Sairam (Holdings) Limited

Brockley Hill, Stanmore - New Banqueting Facility

Supplementary Design and Access Statement

Building Model

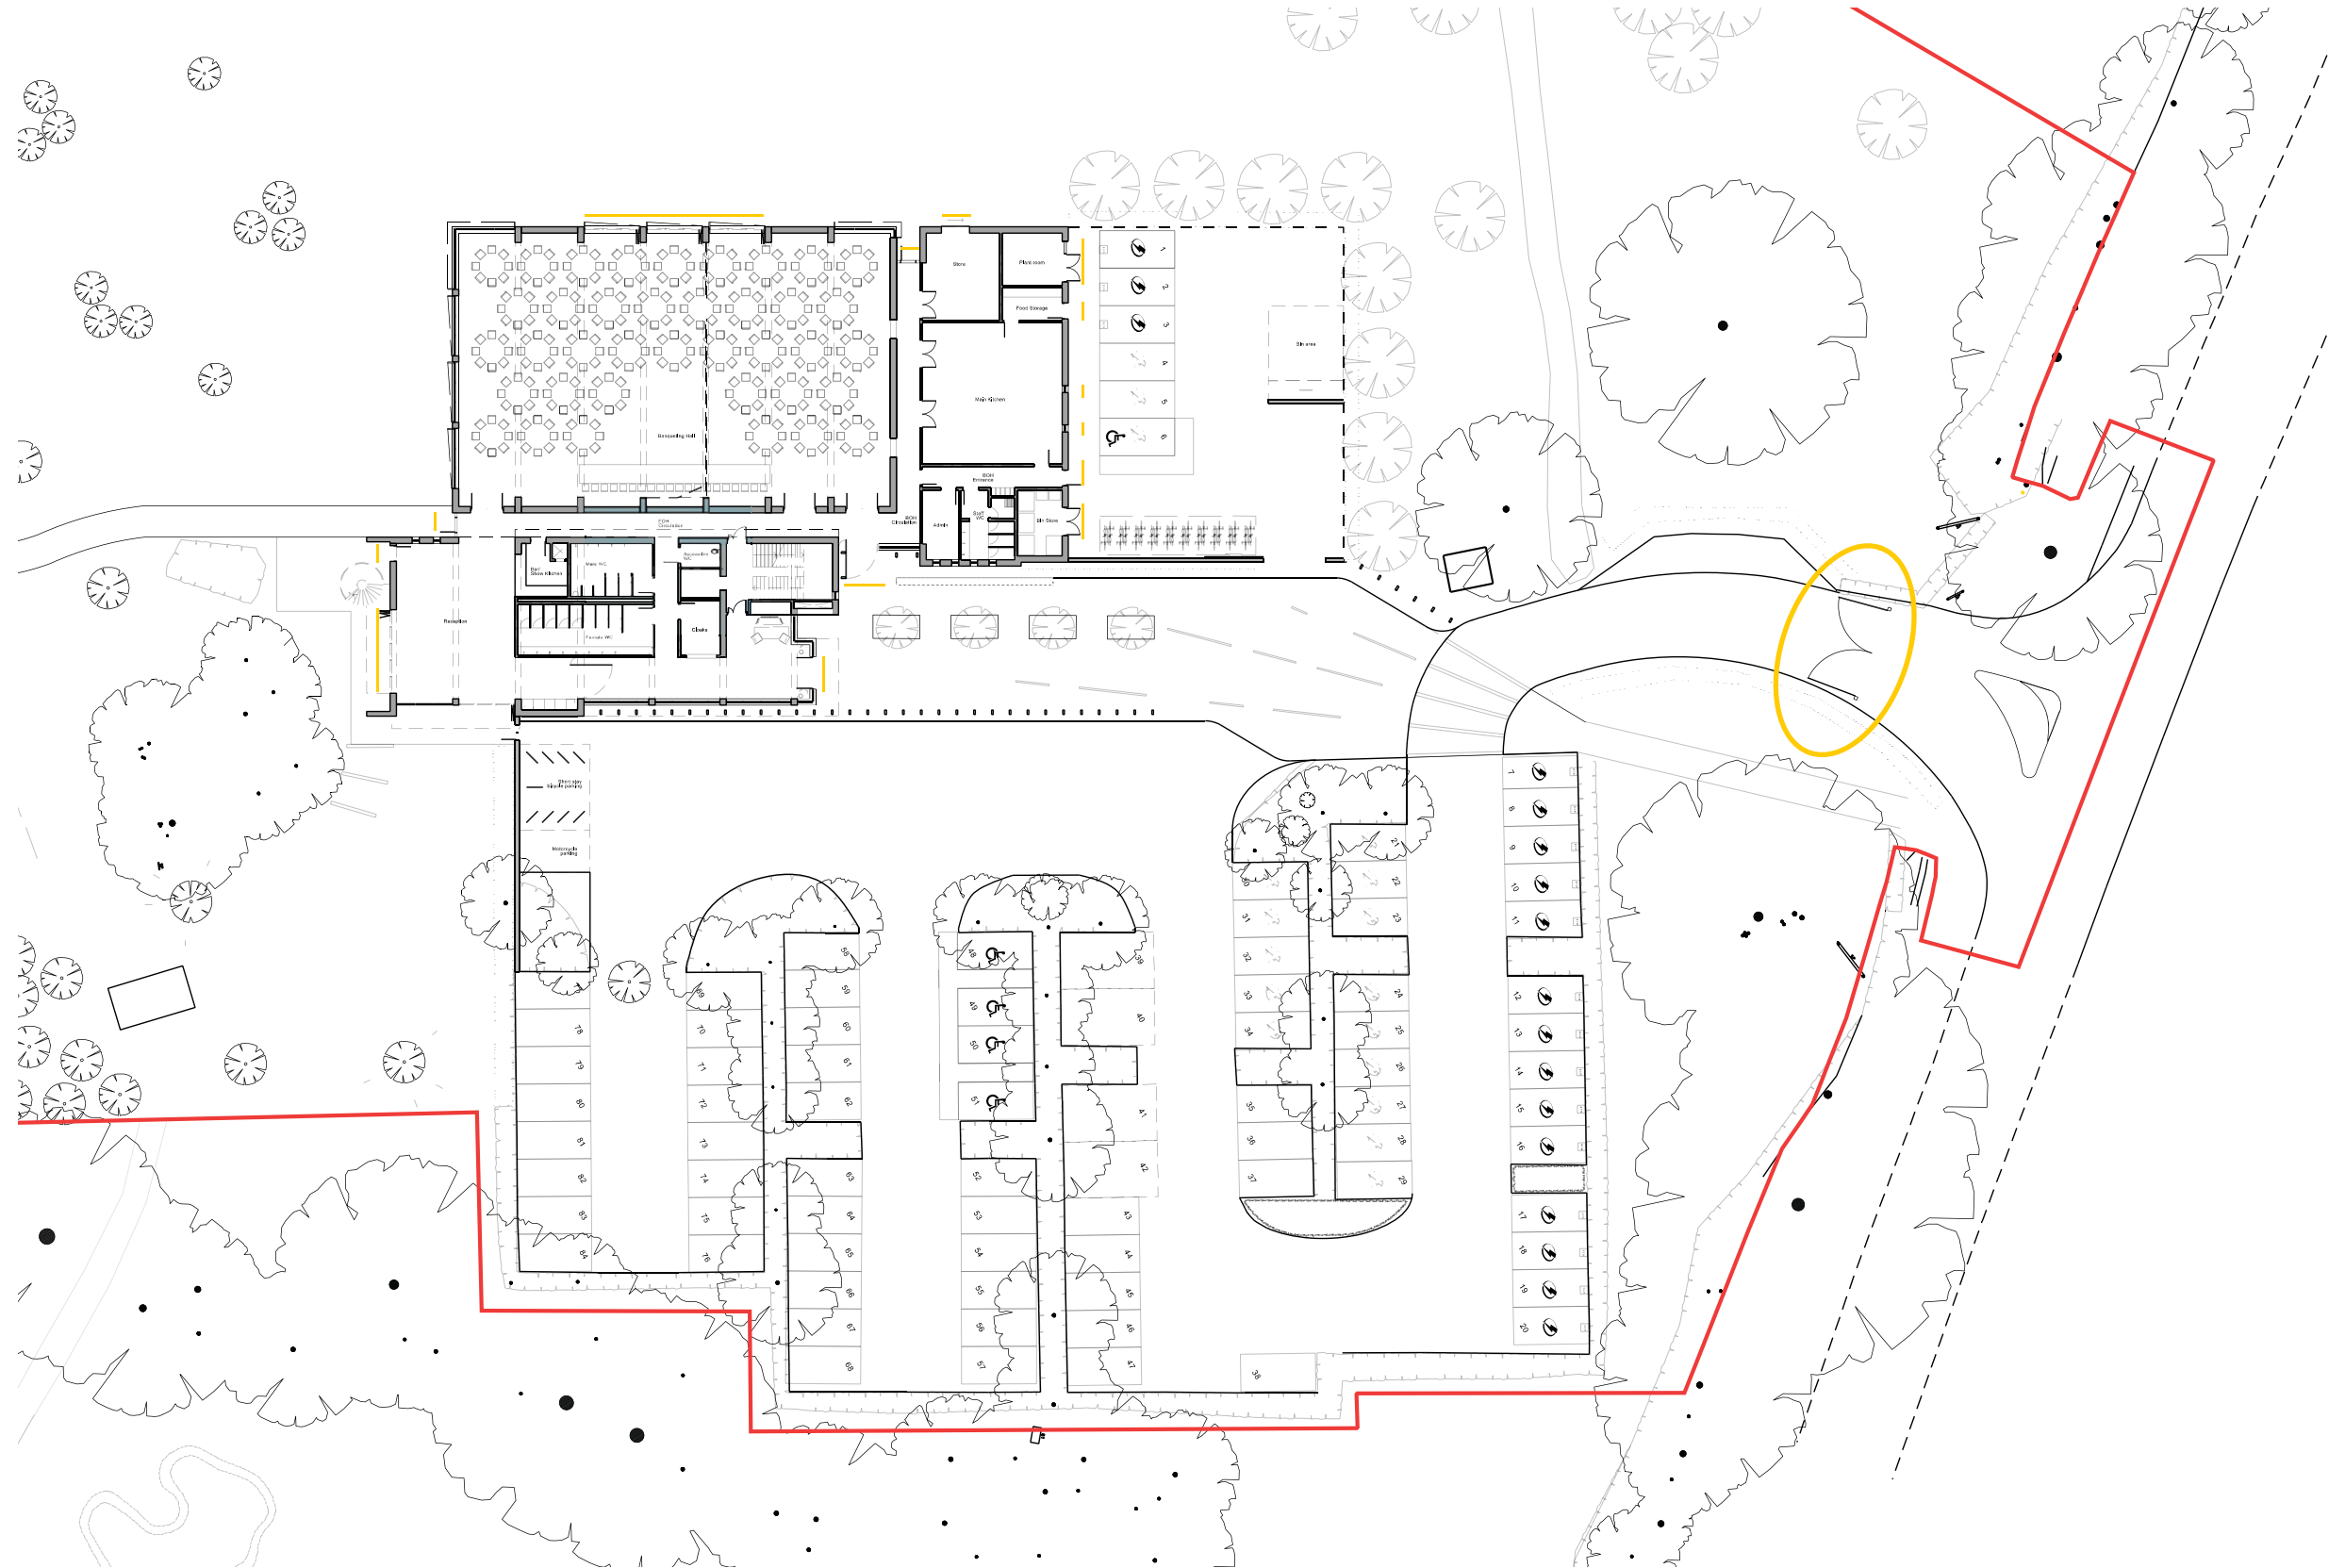
The new proposed massing model (shown on the right) shows the incorporated design changes, predominantly to the south west corner of the Front of House building.

The two images below illustrate the proposed amendment to the south western corner of the building.

Accessibility

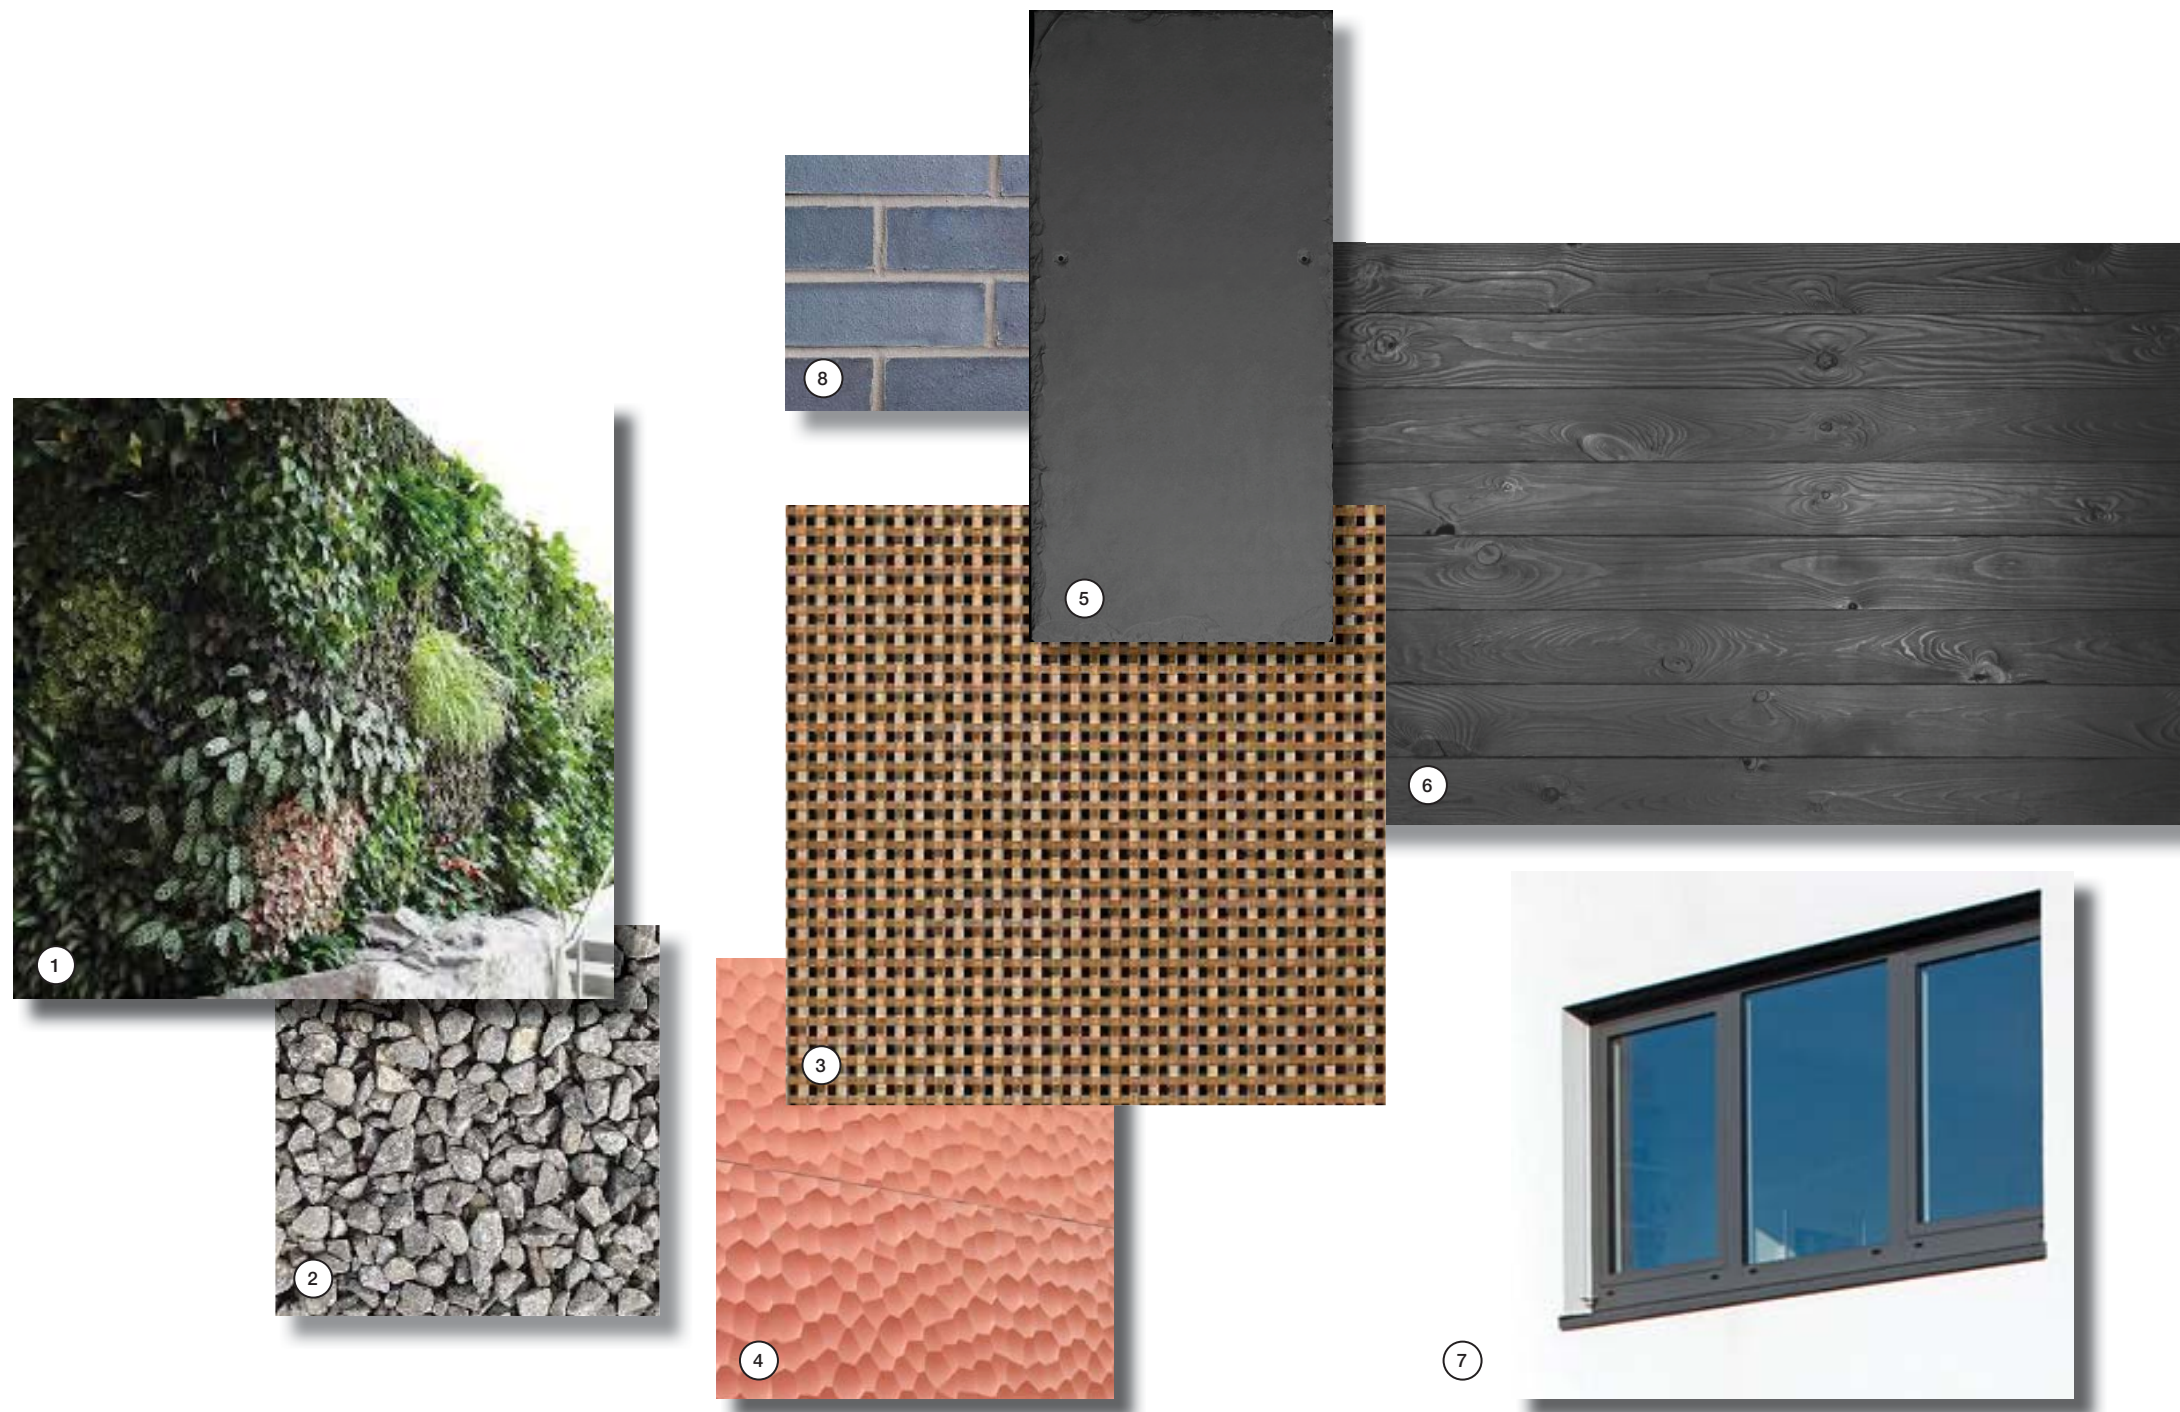
The GLA requested further details in respect of accessibility around the site.

The building forecourt has level access and Part M compliant car parking spaces which are located in close proximity to the main entrance. The back of house yard includes dedicated staff car and cycle parking which includes a disabled car parking bay as well as an enlarged bicycle space.

The Secret Garden is considered an extension to the reception area at ground floor and as such level access between the two is included.

The landscaped gardens will be laid level as much as the existing site topography and existing change in level from North to South allow. The landscaping generally has been designed to include access on paths and along the processional route from site entry point to pagoda. The path will be suitable for wheelchair users, albeit will follow the existing undulation of the landscape.
